## **THE COLONNADES SUBDIVISION, CORRECTED** **PLAT, RESUBDIVISION OF LOTS 12 & 13**

APPLICATION NUMBER 8 DATE March 15, 2012

REQUEST Subdivision

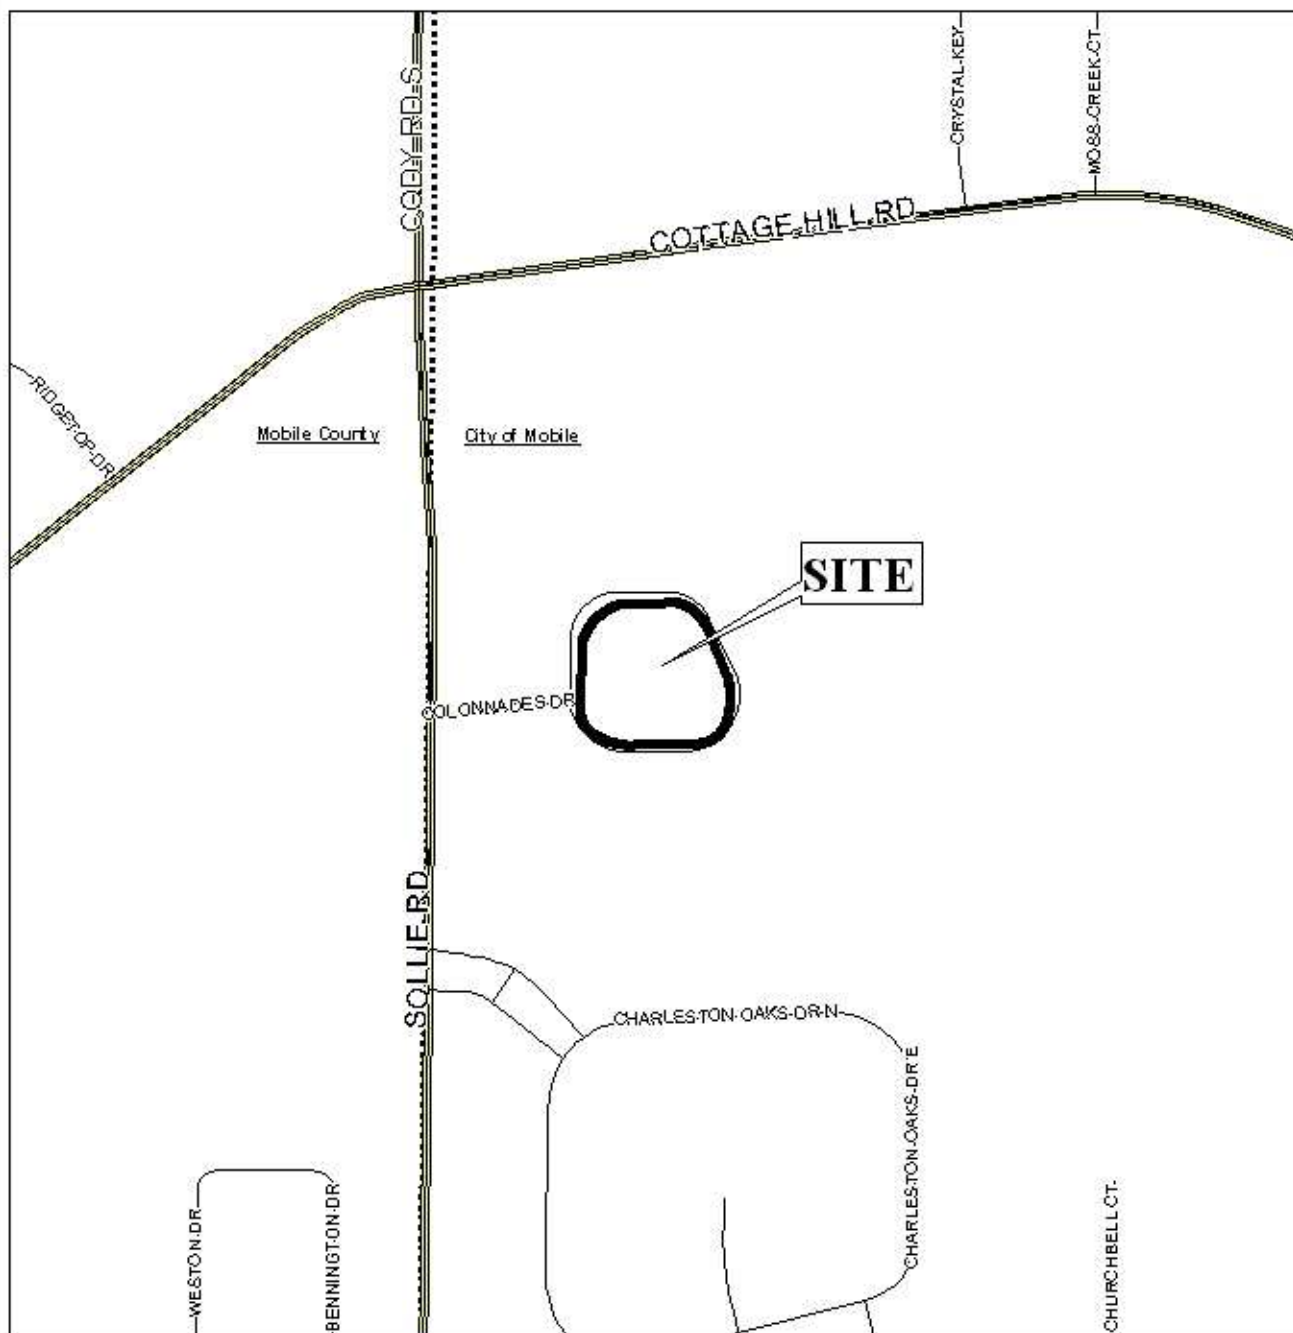
The purpose of this application is to resubdivide two existing legal lots of record into one legal lot of record. Both properties within the proposed subdivision are zoned R-1, Single-Family Residential District. A dwelling currently exists on Lot 12, and Lot 13 is vacant. The new lot would meet the minimum requirements of the Subdivision Regulations with regard to size and shape. The plat should be revised to label the lot with its size in both square feet and acres, or a table should be furnished on the final Plat providing the same information.

The site is located within a subdivision approved by the Commission in 2006 with compliant rights-of-way; therefore, no dedication would be required. As a means of access management, a note should be required on the Final Plat reflecting the Traffic Engineering comments above. As on the preliminary plat, the Final Plat should illustrate the existing 30' minimum building setback line along all street frontages.

The property is located within a subdivision containing common areas; therefore, a note should be required on the Final Plat stating that maintenance of the common areas is the responsibility of the property owners within The Colonnades Subdivision, Corrected Plat, and this resubdivision.

- 1) revision of the plat to label each lot with its size in square feet and acres, or the furnishing of a table on the Final Plat providing the same information;

- 2) placement of a note on the Final Plat stating that the driveway number, size, location and design are to be approved by Traffic Engineering and conform to AASHTO standards;

- 3) illustration of the existing 30' minimum building setback line along all street frontages;
- 4) placement of a note on the Final Plat stating that maintenance of the common areas within The Colonnades Subdivision, Corrected Plat, is the responsibility of the property owners of that subdivision and this resubdivision;

- 5) placement of a note on the Final Plat stating that development of this site must be undertaken in compliance with all local, state and Federal regulations regarding endangered, threatened or otherwise protected species;
